PART MAIN FLOOR PLAN NO.1 - NEW WORK

PAN AM POOL - EAST VESTIBULES

ADDENDUM NO.2

RM-4

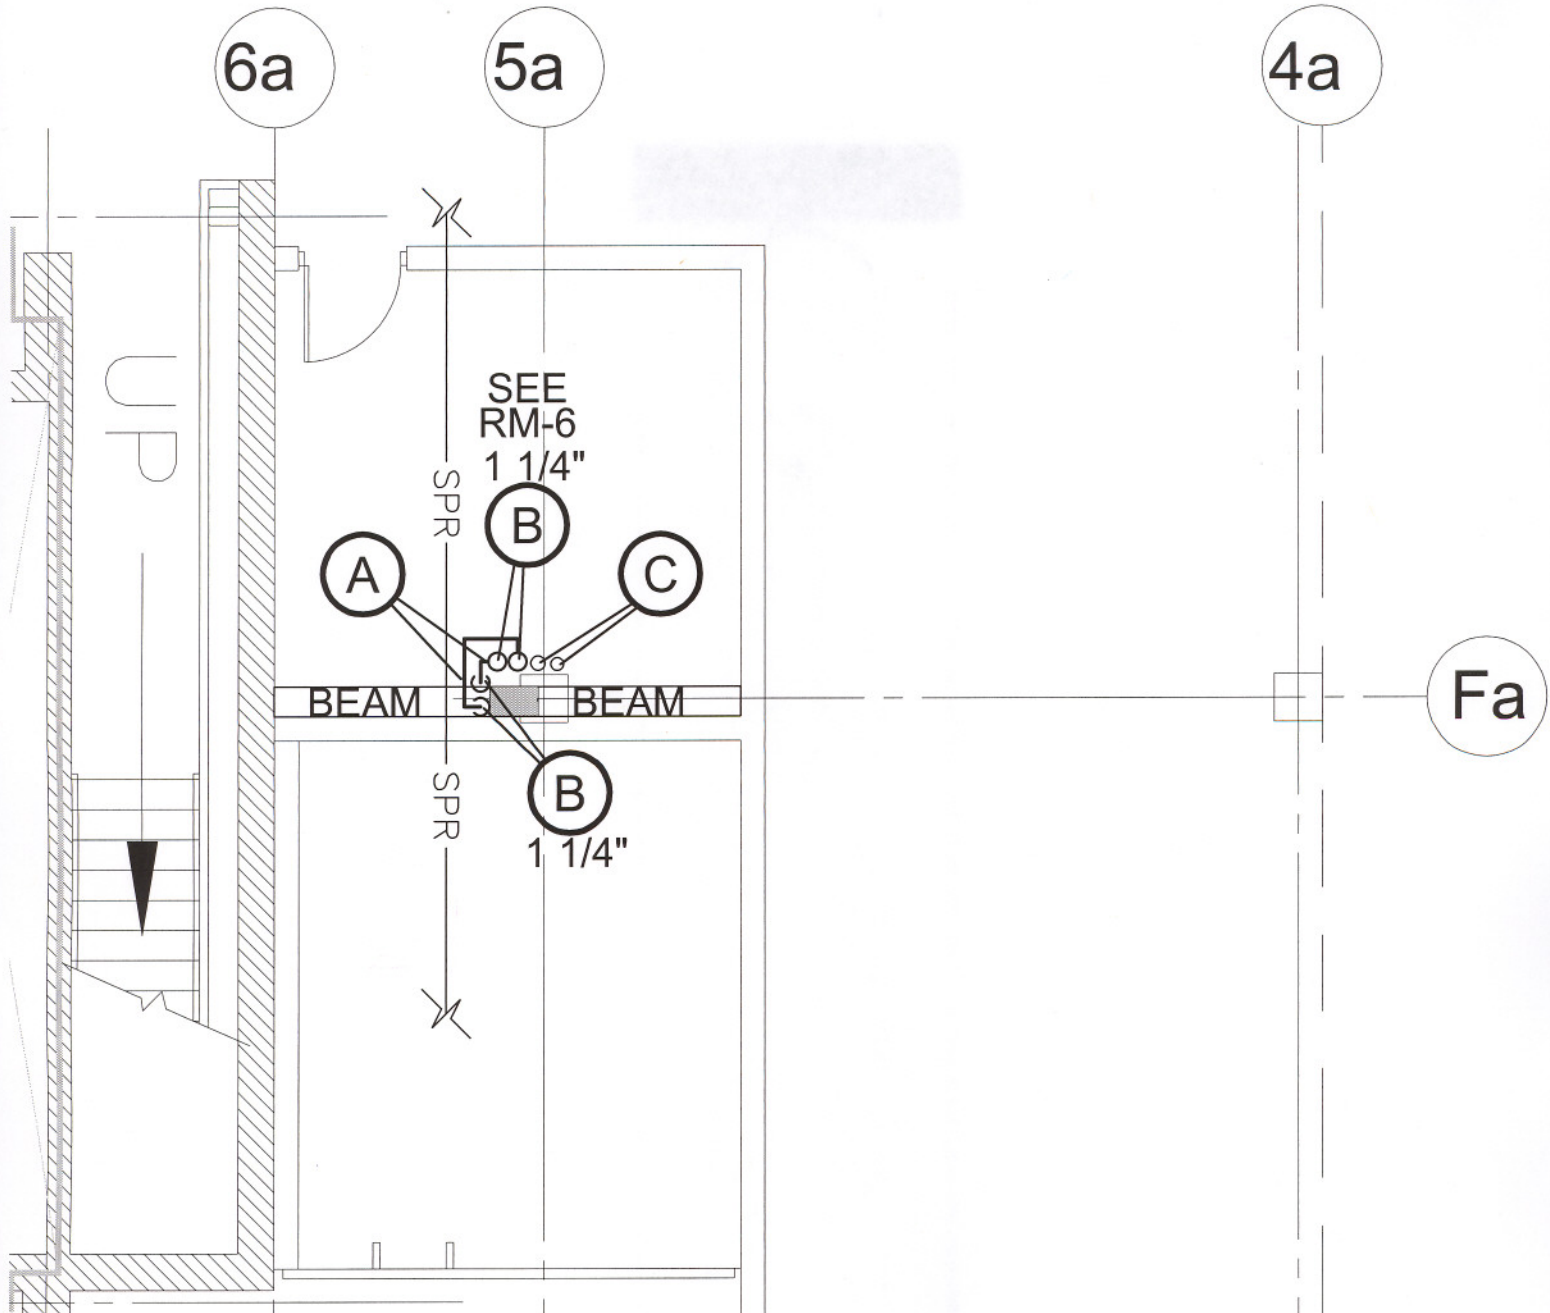
- A. Revised routing.
- B. Revised riser location.
- C. Existing drain, vent and domestic water to remain. Serves drinking fountain at Second Floor.
- D. Extend services to relocated drinking fountain.
- E. Existing drinking fountain shown relocated +/- 2'-0".
- F. See Architectural for new enclosure.
- G. Reconnect vent.
